The Calcutta Gazette

APPENDIX.

NOTICES TO MARINERS.

The following Notices are republished for general information.

Charts affected.—No. 1102, Cleveland bay and plan of Townsville harbour.

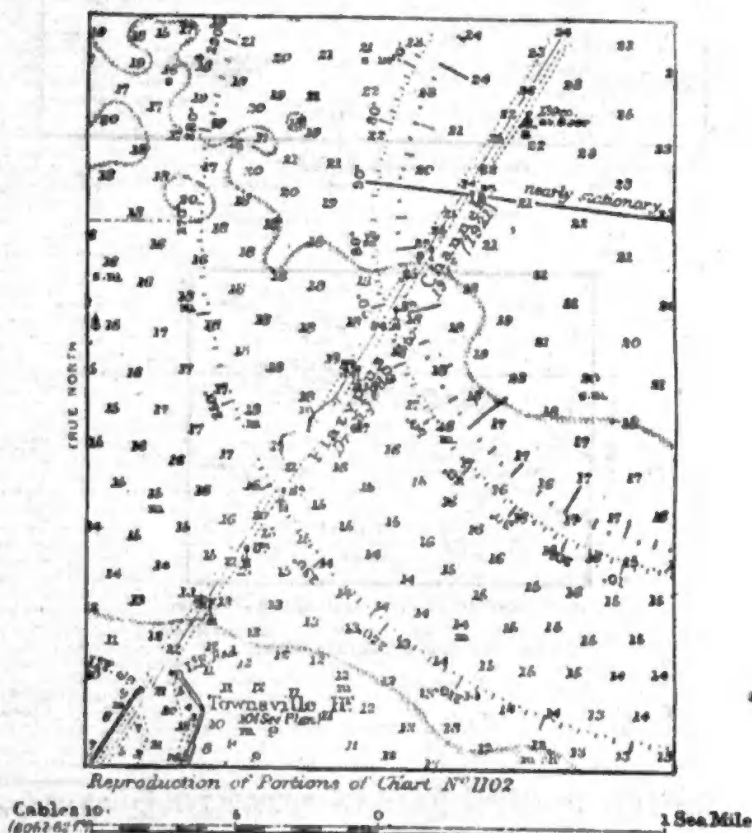
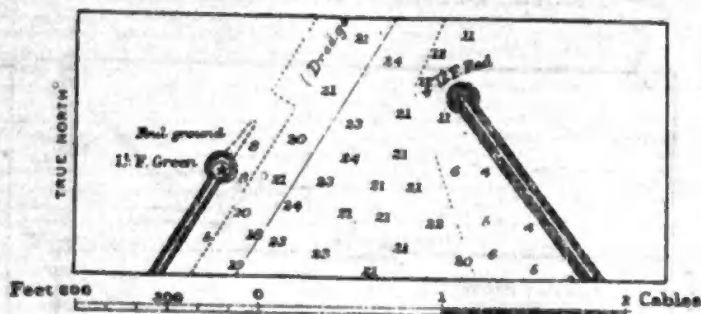
Details.—The accompanying reproduction of a portion of chart No. 1102 shows the necessary amendments to the chart with regard to Platypus channel, in the approach to Townsville harbour. Attention is drawn to the establishment of eight black beacons, the withdrawal of three conical black buoys, the alteration in the position of the light-buoy marking the north-eastern end of the dredged channel and the existence of foul ground off the north-eastern extremity of the Western breakwater. The fixed green light near the seaward end of Western breakwater has been moved a distance of 200 feet (61m0) to the north-eastward.

Note.—Tidal signals are no longer made from Bay rock and the note on chart No. 1102 is to be amended accordingly.

Reproduction of Portion of Chart N° 769

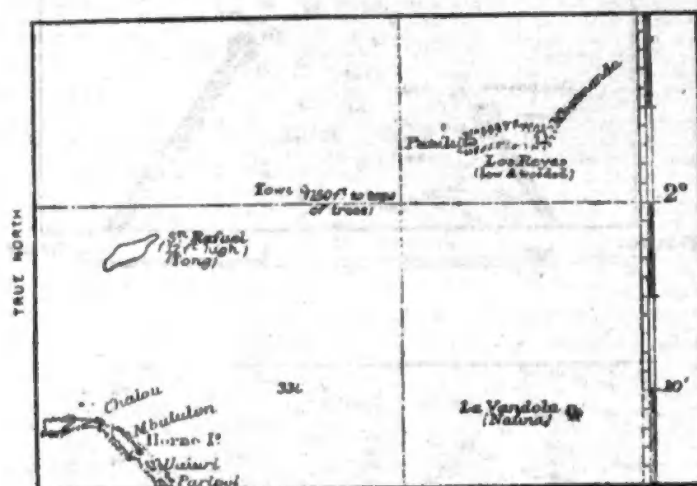
Details.—The accompanying reproduction of portions of charts Nos. 769 and 2766 shows the necessary amendments to the charts with regard to the positions of La Vandola (Nauna) and San Rafael (Tong) islands, also the height of the trees on Towi island.

Reproduction of Portion of Chart N° 1100

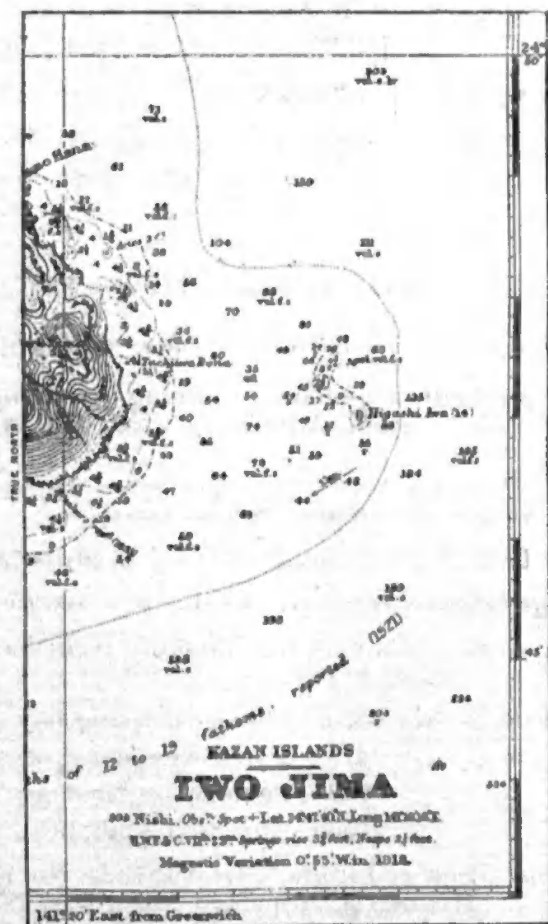
Details.—The accompanying reproduction of a portion of the plan of Iwo jima on chart No. 1100 shows the necessary corrections to that plan with regard to a shoal extending north-westward from Higashi iwa and depths in the vicinity.

Note.—It will be observed that the note with regard to rocks and breakers reported between Iwo jima and Higashi iwa has been omitted from the reproduction.

Charts affected.—No. 359, Nagasaki to Karatsu, with the Goto islands.

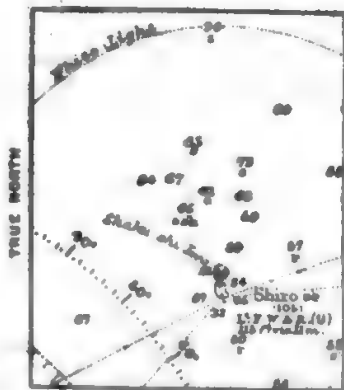
The rock, the existence of which was doubtful, reported in the year 1914 about $1\frac{1}{2}$ miles northward of Shiro se lighthouse, does not exist and is therefore omitted from the reproduction.

Charts affected.—No. 208, Plan of Shiriya-saki anchorage.

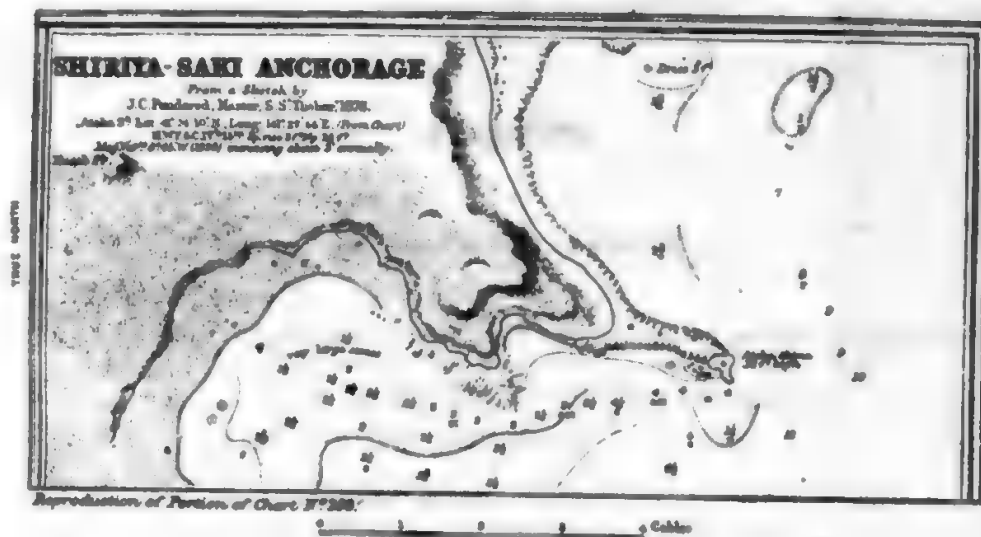
Details.—General amendments to the chart with regard to the coastline and rocks in the vicinity of Ataka shima are shown on the accompanying reproduction of a portion of the undermentioned plan on chart No. 208.

Remarks.—The symbol for a rock with a depth of less than 6 feet ($1^m 8$) is to be inserted in lat. $41^{\circ} 24' 40' N.$, long. $141^{\circ} 28' 10' E.$ on chart No. 2441.

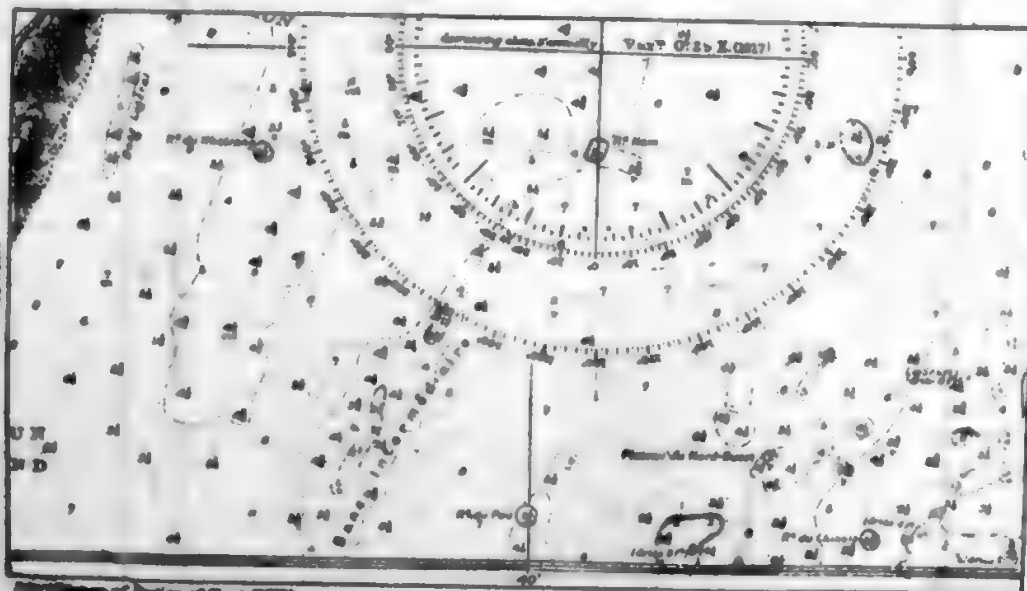
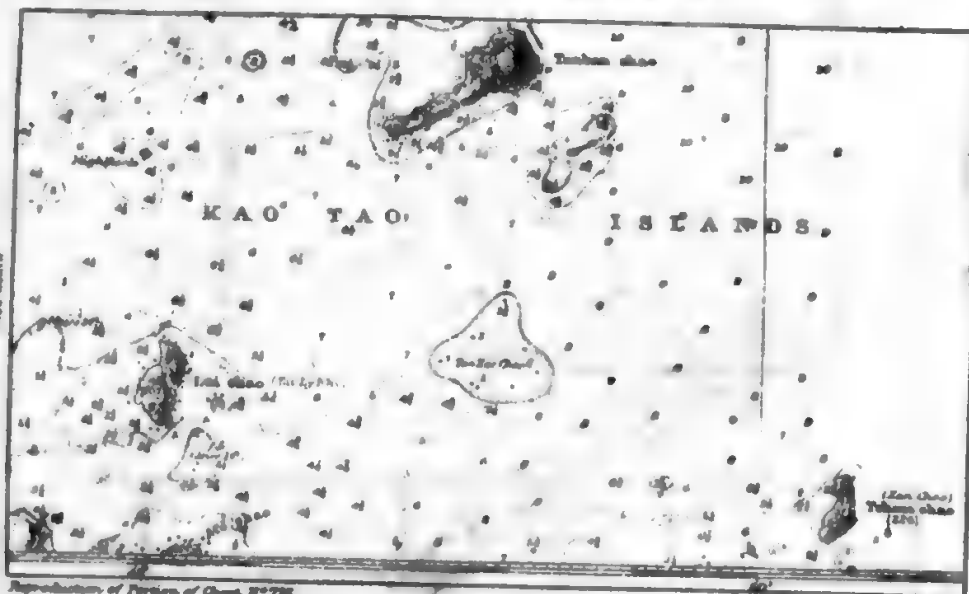
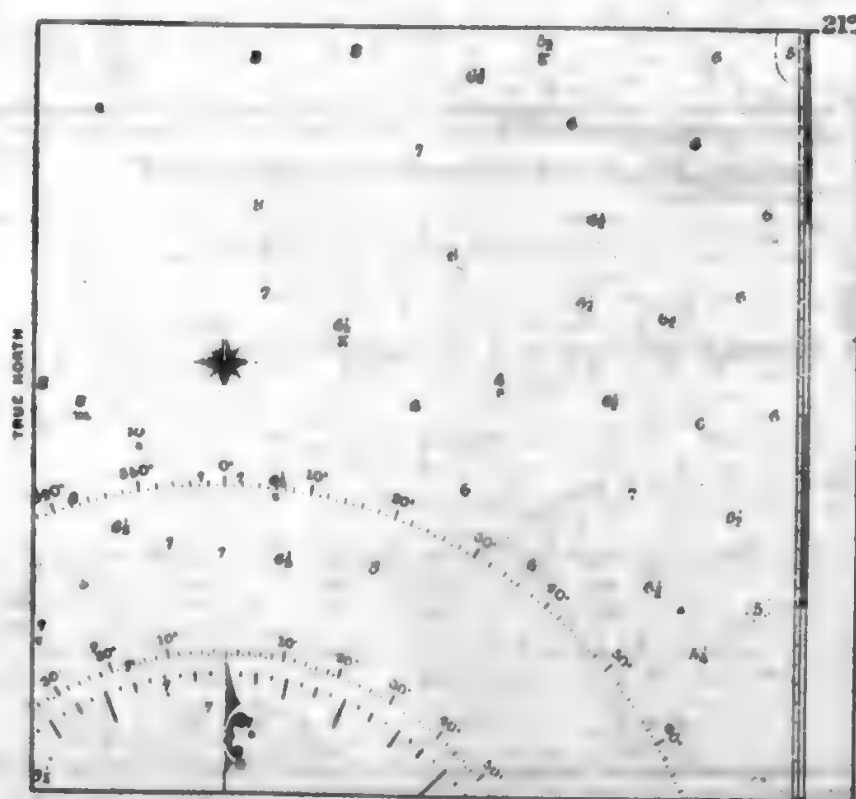
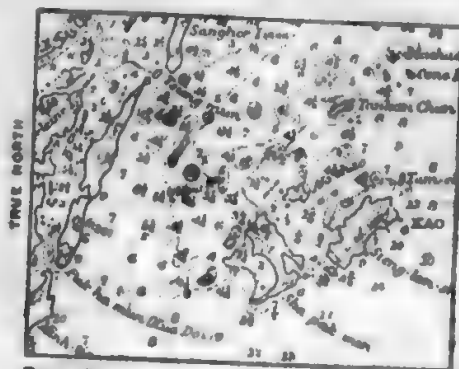
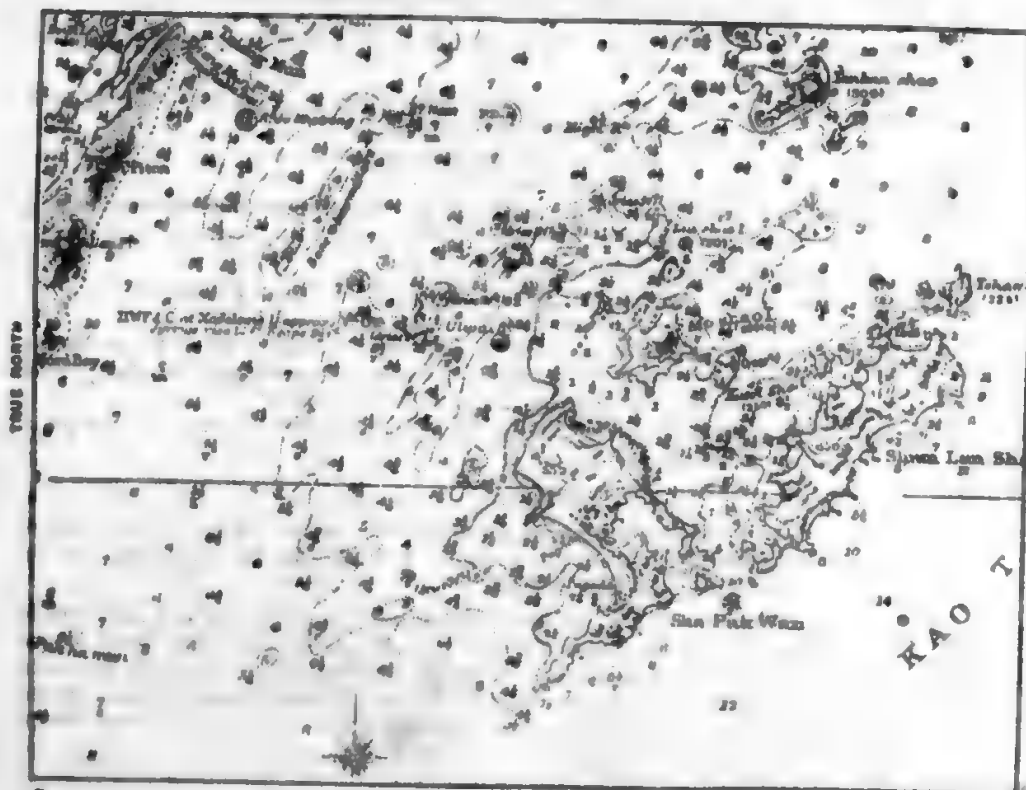
Details.—The accompanying reproductions of portions of charts Nos. 776, 1965, 1169, 2062 and 2661a, show the necessary amendments to the charts with regard to shoals and depths in the vicinity of, and to the westward of the Kao Tao islands. The depth on Hugon rock at the southern end of Sanglier island is one fathom (1^m8), and not 1½ fathoms as hitherto shown on the charts.

Charts affected.—No. 359, Nagasaki to Karatau, with the Goto islands.

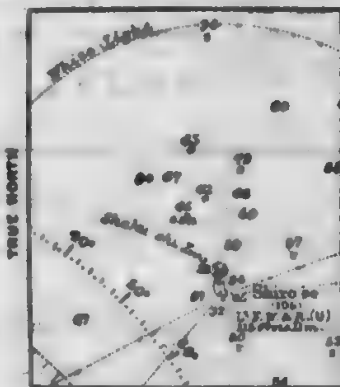
The rock, the existence of which was doubtful, reported in the year 1914 about $1\frac{1}{2}$ miles northward of Shiro se lighthouse, does not exist and is therefore omitted from the reproduction.

Charts affected.—No. 208, Plan of Shiriya-saki anchorage.
" 2441, Tsugaru Kaikyo.

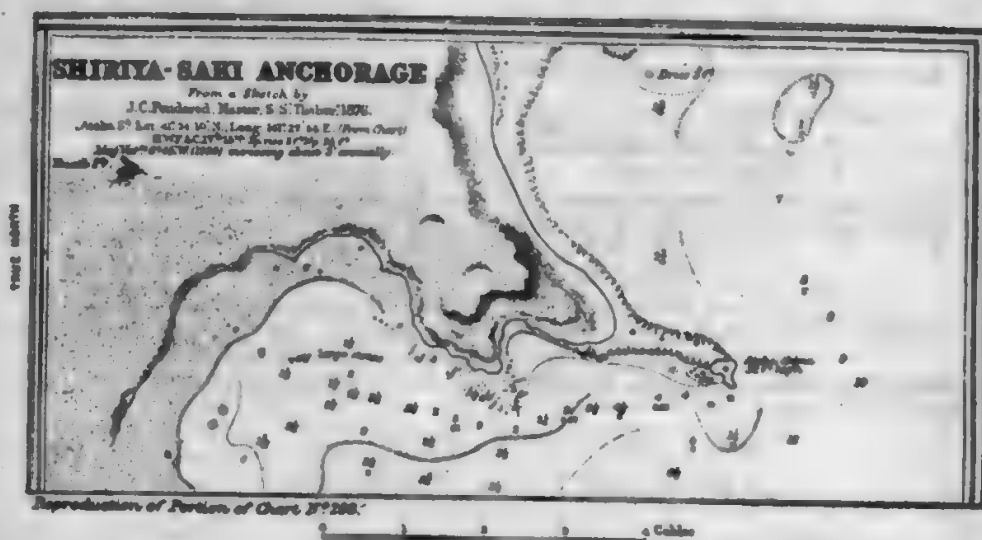
Details.—General amendments to the chart with regard to the coastline and rocks in the vicinity of Ataka shima are shown on the accompanying reproduction of a portion of the undermentioned plan on chart No. 208.

Remarks.—The symbol for a rock with a depth of less than 6 feet (1^m8) is to be inserted in lat. $41^{\circ} 24' 40' N.$, long. $141^{\circ} 28' 10' E.$ on chart No. 2441.

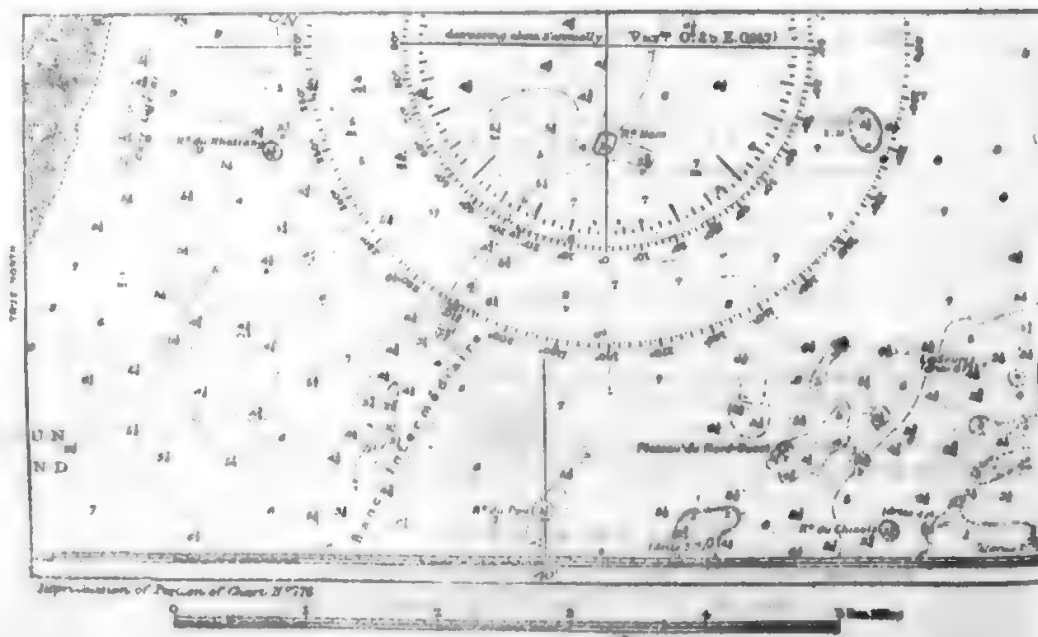
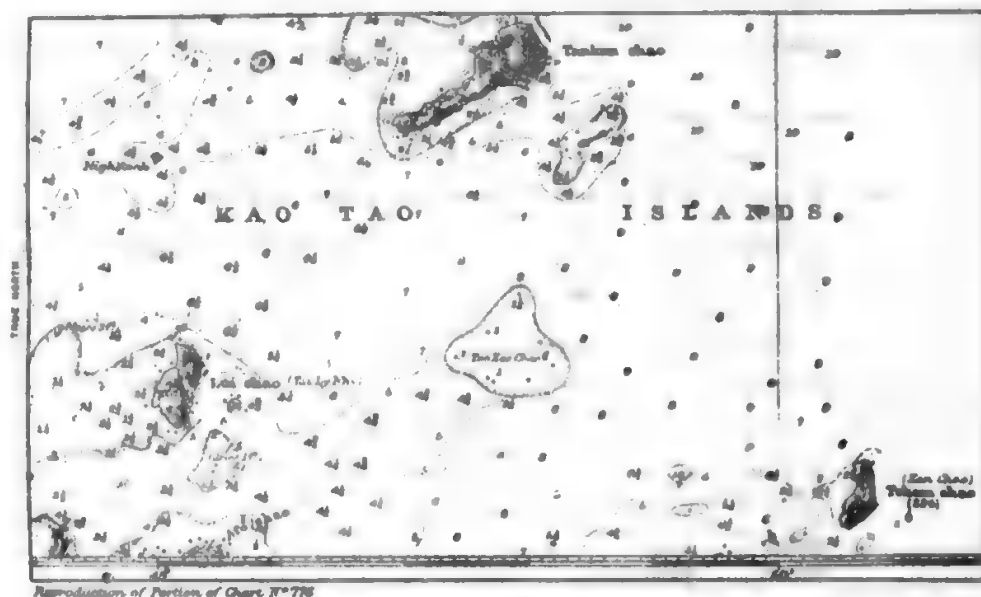
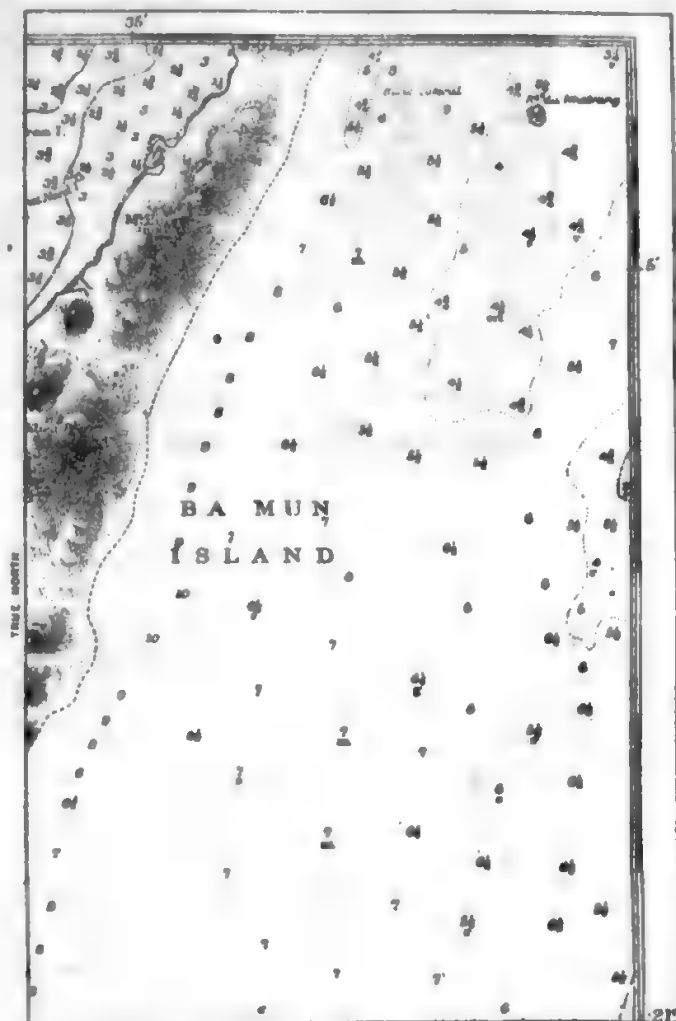
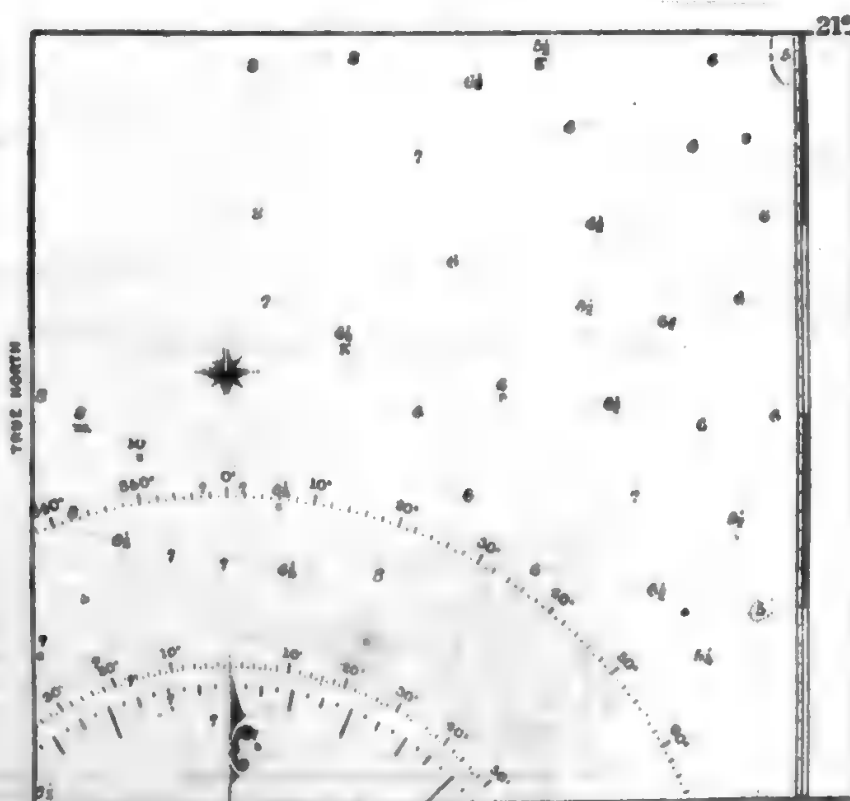
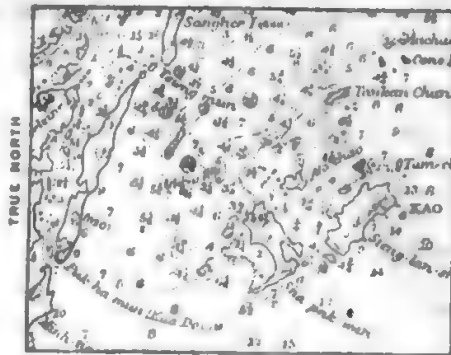
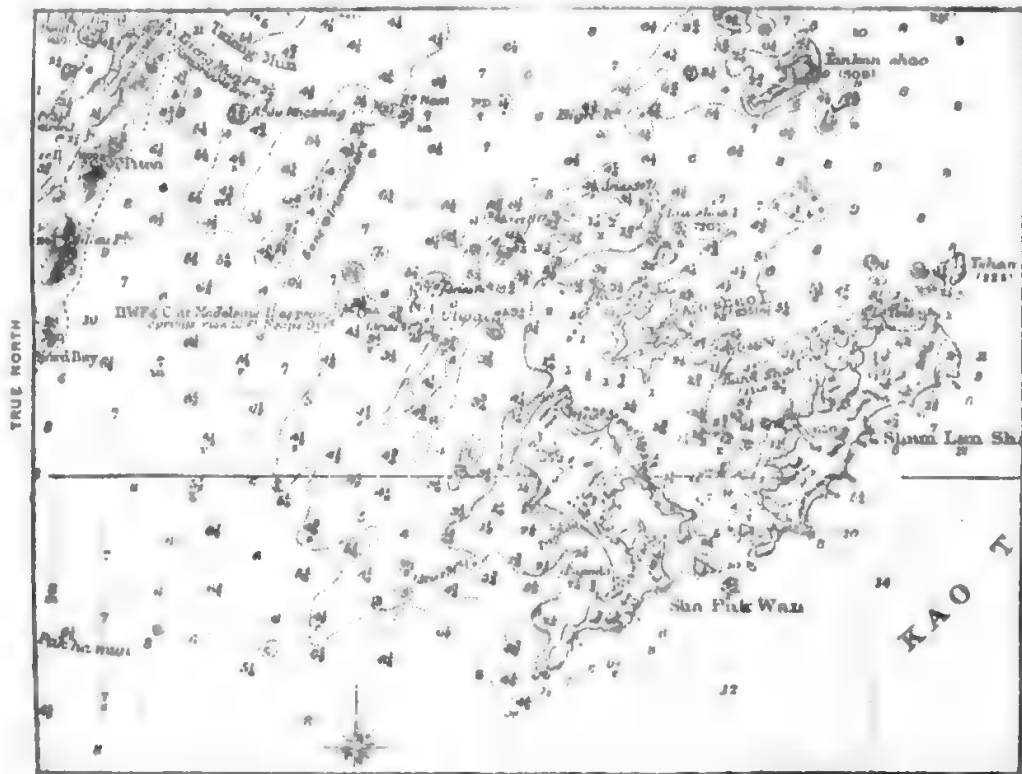
Details.—The accompanying reproductions of portions of charts Nos. 776, 1965, 1169, 2062 and 2661a, show the necessary amendments to the charts with regard to shoals and depths in the vicinity of, and to the westward of the Kao Tao islands. The depth on Hugon rock at the southern end of Sanglier island is one fathom (1^m8), and not 1½ fathoms as hitherto shown on the charts.
